**ADDENDUM NO. 2  
TO  
CONTRACT DOCUMENTS  
FOR  
653 COOK AVENUE**

**DATE:** November 1, 2013

**ADD:** Stair revision drawings for the First to Second Floor stairway wall.  
Kitchen / Old Porch floor insulation drawing.  
Structural information has been added in a memo dated September 18, 2013.

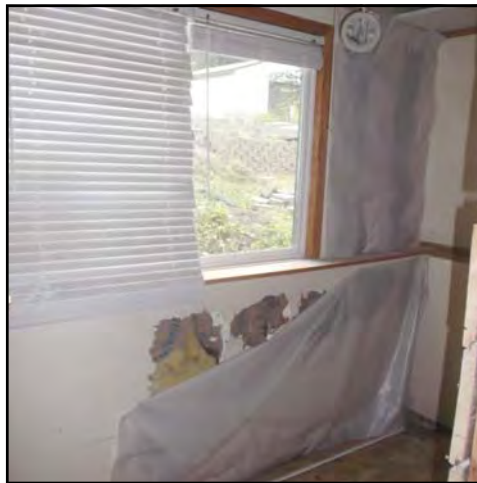
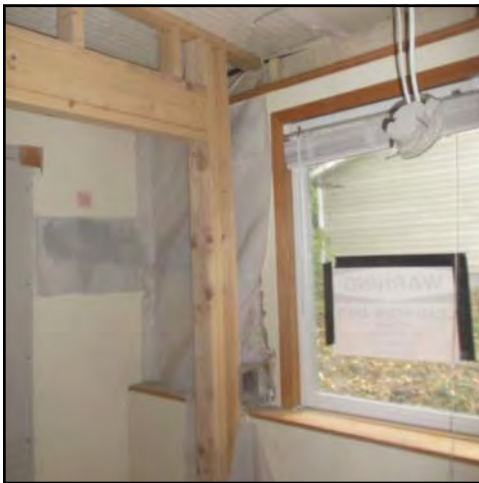
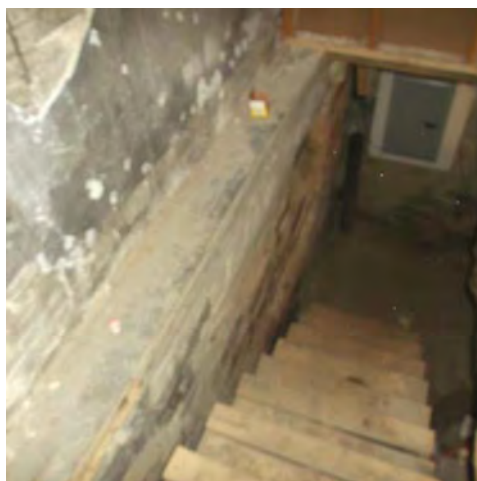
These two images are of the sun tube that was installed in the second floor bathroom. The perimeter of the sun tube at the attic floor needs to be sealed. Currently, there is no cover to the sun tube and birds could easily get into the house.

Since the drywall is damaged in the back walls of the addition, it is recommended that the damaged portions be removed and that the wall be re-insulated with new fiberglass batts.

Left image- Visual inspection of the ceiling cavity of the back addition through a small hole showed that it is un-insulated. Prior to insulating the ceiling to capacity with cellulose, the edges of the ceiling should be sealed with caulk.

Right image- The blower door test indicated the top of the foundation along the basement stairwell was leaky and needs to be sealed

# Insulation under rear Kitchen / Old Porch

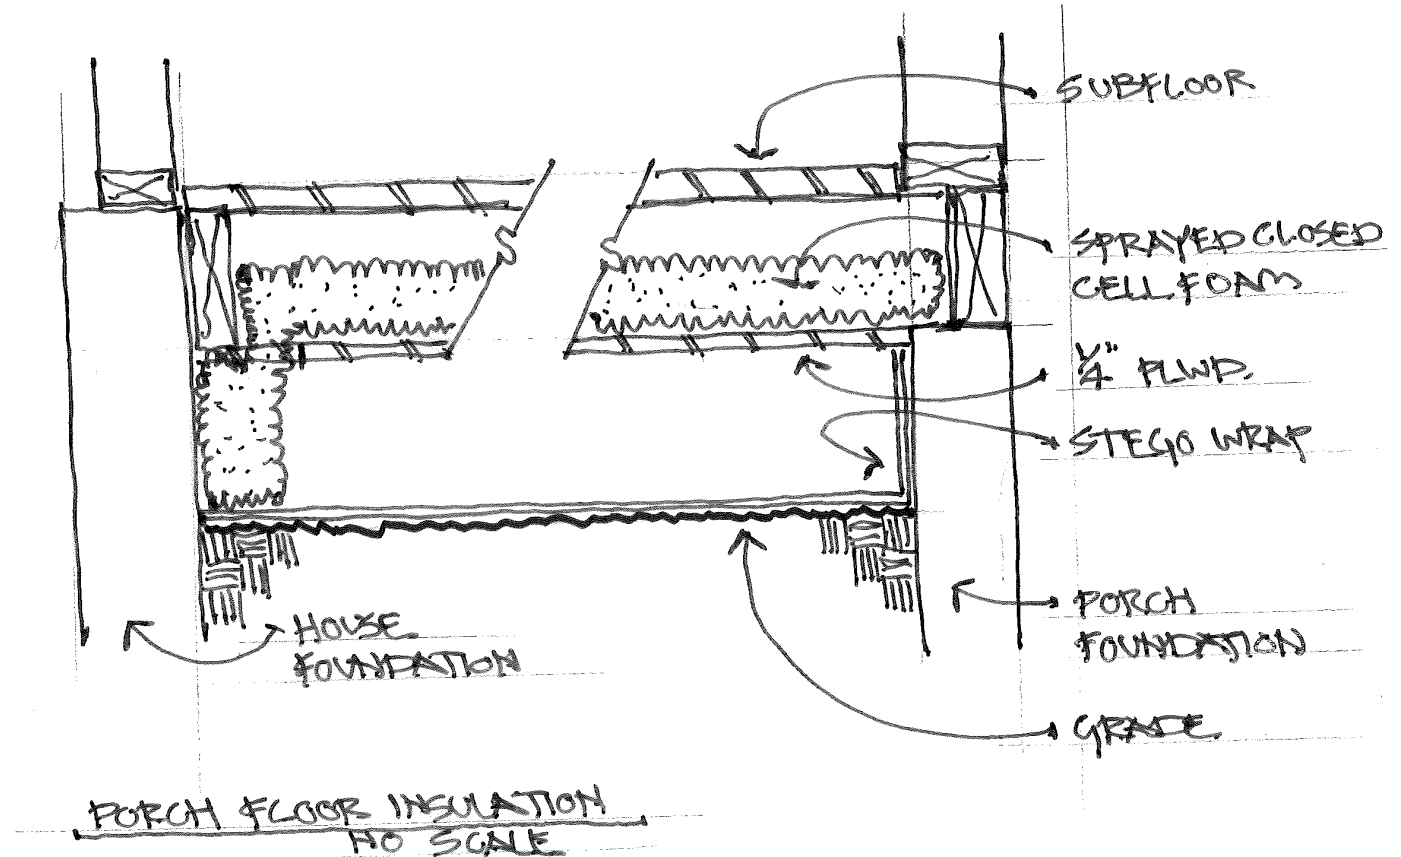
1. Provide and install 16 mil Stego Wrap vapor barrier on grade and along porch foundation wall.
2. 1/4" plywood nail to bottom of floor joists - this to hold spray foam in place.
3. Spray closed cell foam along house foundation wall and continuous in between floor joists - this will also provide a vapor barrier for the floor.
4. Reinstall subfloor.
